HWY 701 TO HWY 544 48" WATER TRANSMISSION LINE IMPROVEMENT PROJECT

BID TABULATION

Consulting Engineers
Surveyors
Land Planners
Landscape Architects
Environmentalists

October 28, 2019
Revised December 04, 2019

GSWSA-
WACC...1.1.dwg

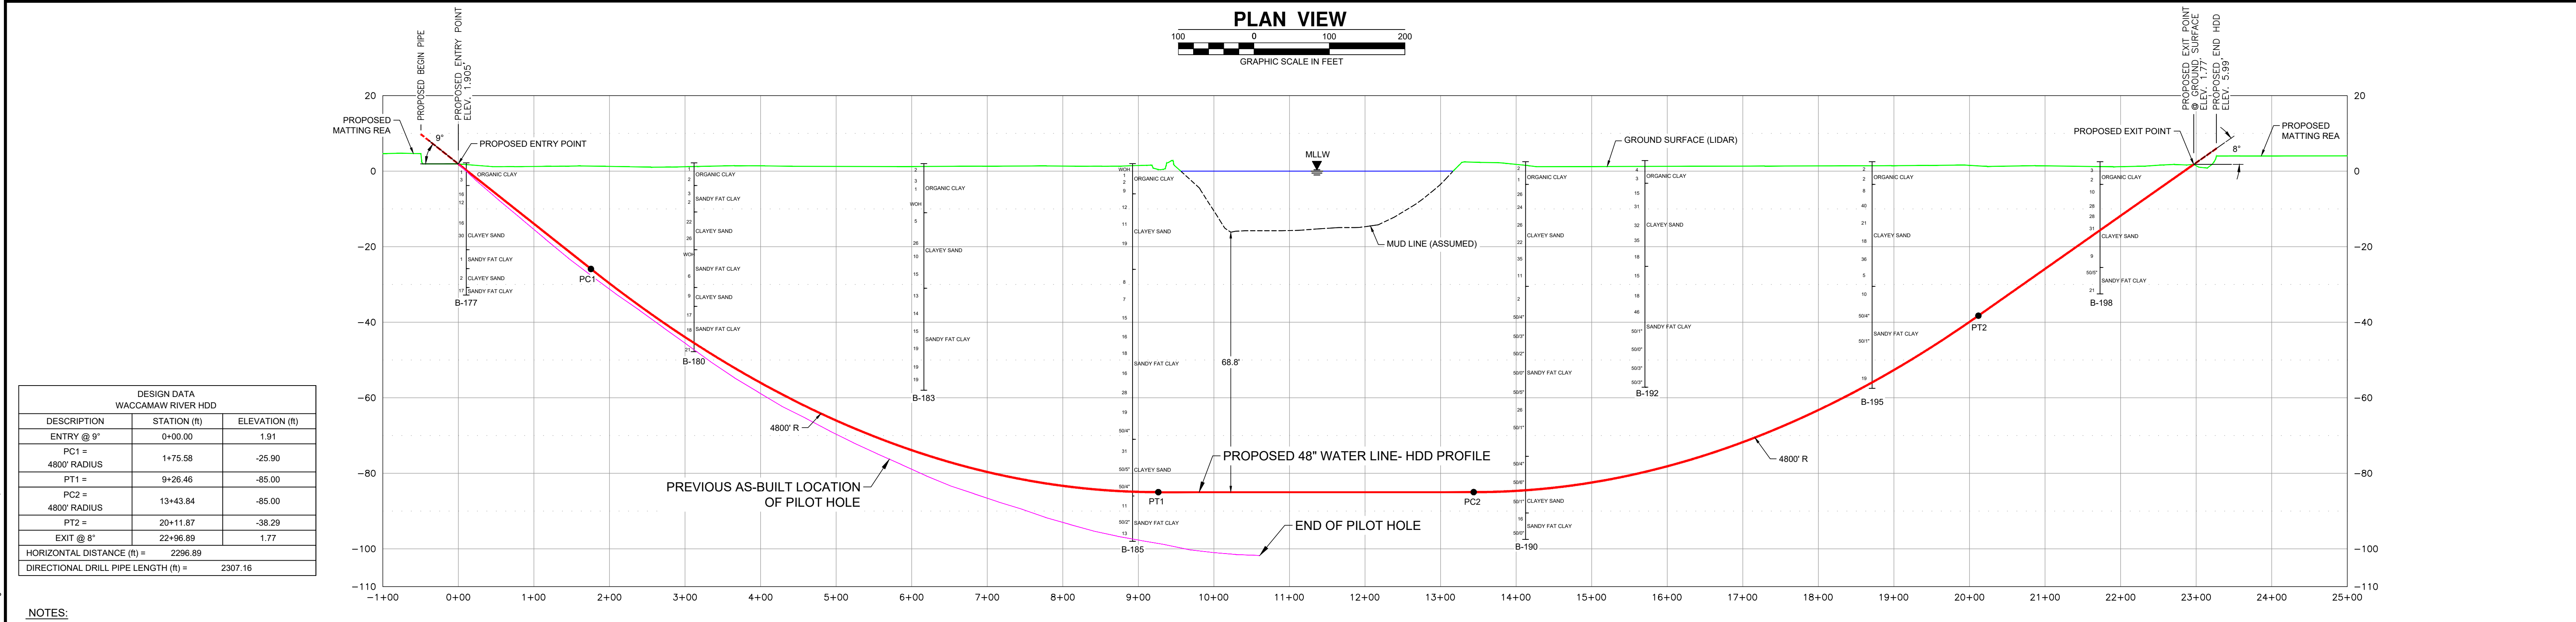
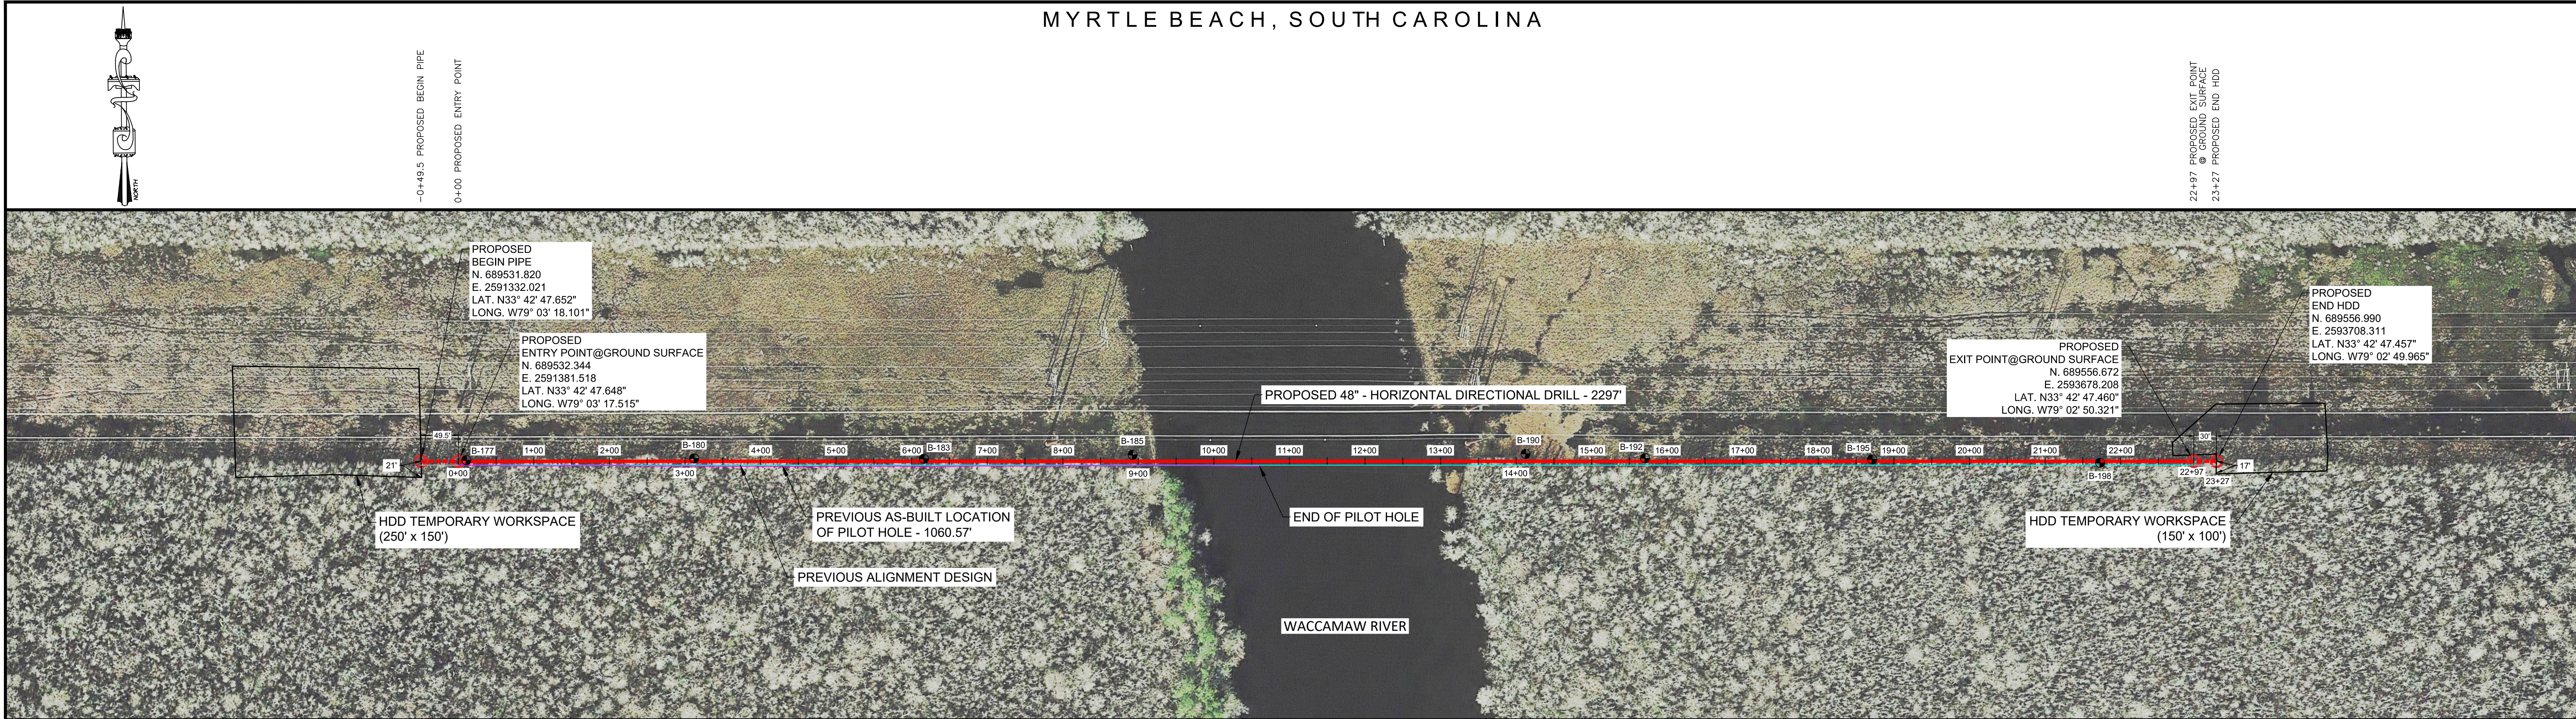
As you know, Laney has encountered some difficult ground conditions while performing the pilot hole for the HDD. They said the hole alignment has deviated as a result and is no longer in spec. They believe the best course of action is to pull out, shift over 5 feet (toward the powerline), and start a new hole.

See attached revised HDD design from Laney.

DESIGN DATA WACCAMAW RIVER HDD		
DESCRIPTION	STATION (ft)	ELEVATION (ft)
ENTRY @ 9°	0+00.00	1.91
PC1 = 4800' RADIUS	1+75.58	-25.90
PT1 =	9+26.46	-85.00
PC2 = 4800' RADIUS	13+43.84	-85.00
PT2 =	20+11.87	-38.29
EXIT @ 8°	22+96.89	1.77
HORIZONTAL DISTANCE (ft) =	2296.89	
DIRECTIONAL DRILL PIPE LENGTH (ft) =	2307.16

PIPE SPECIFICATIONS			
1. PRODUCT PIPE WILL CONSIST OF 48" O.D. X 0.750 W.T., API-5L X-52 PIPE WITH 14-16 MILS OF FUSION BONDED EPOXY (FBE) AND 30-40 MILS AIR.			
2. MAXIMUM ALLOWABLE OPERATING PRESSURE (MAOP) = 80 psi.			
REV.	DATE	REVISION	BY
△	12/28/2020	SHIFTING ENTRY & EXIT POINTS 5 FT NORTH	EHT
△	11/05/2020	RELOCATED EXIT POINT 30 FT WEST	EHT
△	11/04/2020	REVISED ALIGNMENT PER NEW SURVEY	EHT
△	10/20/2020	REVISED ALIGNMENT PER NEW ENTRY & EXIT COORDINATES LOWERING BOTTOM TANGENT BY 10 FT	EHT
△	08/16/2020	PROPOSED PLAN AND PROFILE	EHT
